Traffic Committee Meeting

MINUTES

Wednesday, 02 March 2022

8.7. Footpath and Refuge Installation - Boomerang Avenue, Albion Park Rail

Attachment 1 to Item 8.7 Footpath and Refuge Installation - Boomerang Avenue, Albion Park Rail

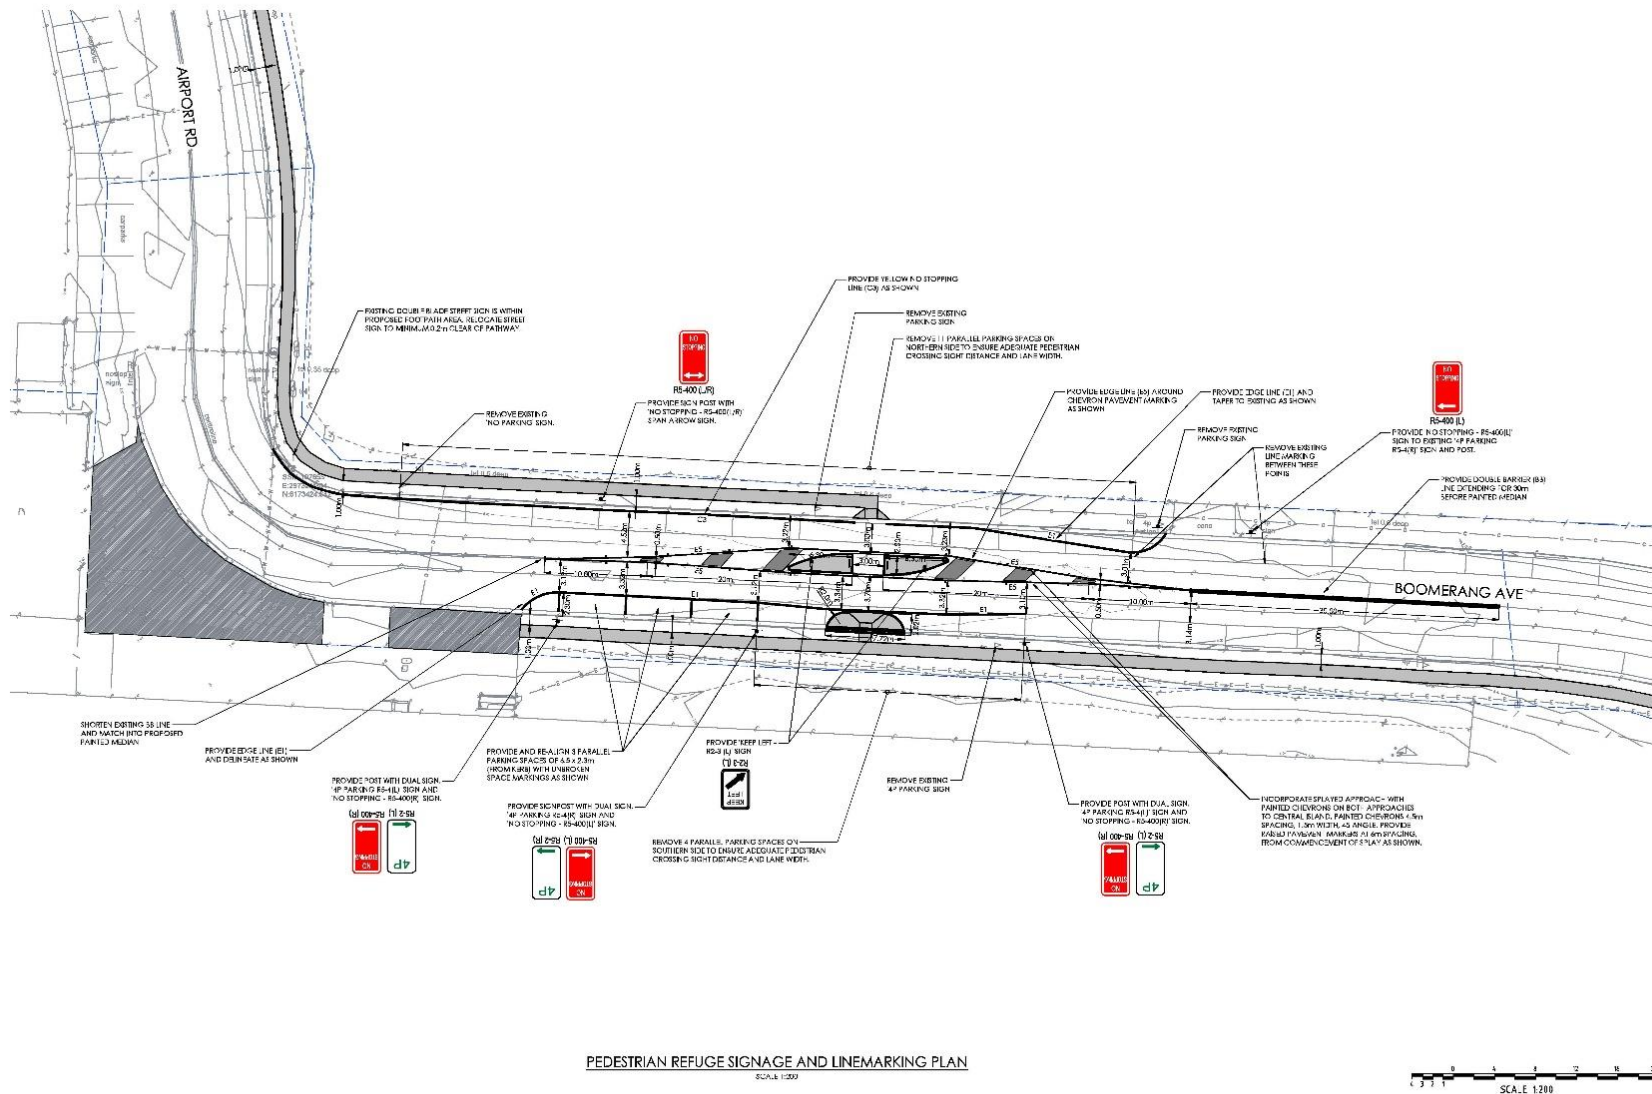
That Council approve the installation of a pedestrian refuge (with associated signage and linemarking) on Boomerang Avenue, Albion Park Rail as shown in the signage & linemarking plan illustrated **Attachment 1** (*page 7 of these Minutes*) subject to the tapers on approach to the refuge being extended by 5m on either side.
